DEVELOPMENT REVIEW BOARD REPORT

SUBJECT Horseman Park Estates

REQUEST Request Preliminary Plat approval for eight single-family on a 2.9+/- acre

22-PP-2004

HORSEMAN'S PARK II PRELIMINARY PLAT

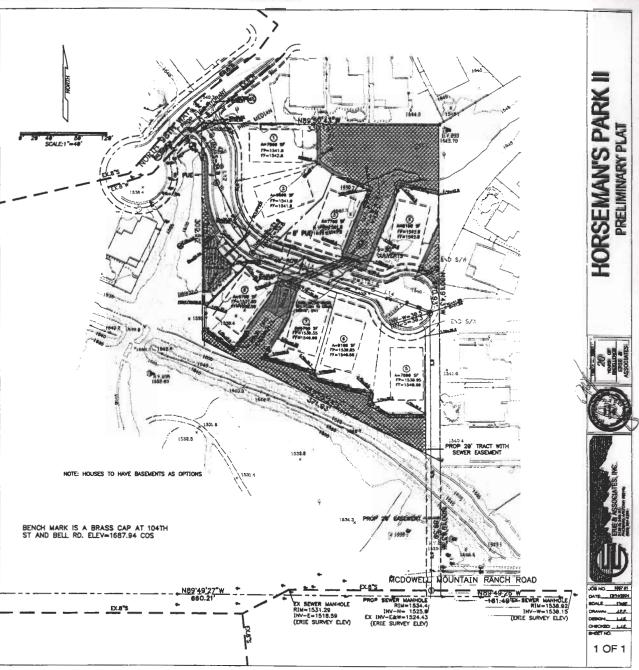
- 28. The drainage report prepared by Erie and Associates, dated January 17, 2005, for Horseman's Park 22-PP-04, shall be revised to demonstrate that in line stormwater storage is provided on the upstream side of the culvert; show basins designed shall be such that the depth of water does not exceed 3 feet for all storm frequencies up to the 100 year 2 hour event; correct the volume calculations for basin 2 in Appendix A to show a storage volume not to exceed 0.12 acre feet; name the wash in the middle of the site, Wash A; for every cross section on Wash A and reach throughout the site, label the river station, water surface elevation and the top width of floodplain on the pre and post development G&D plan.

- 32. Revise the full size pre development drainage site plan: Show flowrates and velocity at all CP's, show existing contour elevations and label the contours, show flowlines. Show and label the 100 yr floodplain.

- 34. Show post development contours on the post development site plan for all features including streets, detention basins, and the realigned wash and culvert section.

- 39. Show and label the flow paths on each site plan. Use the dashed line to show the flowline of the wash bottom.how more pavements grades for the proposed internal street so we can see how the water is draining to the detention basins. Show all grade breaks and use flow arrows.
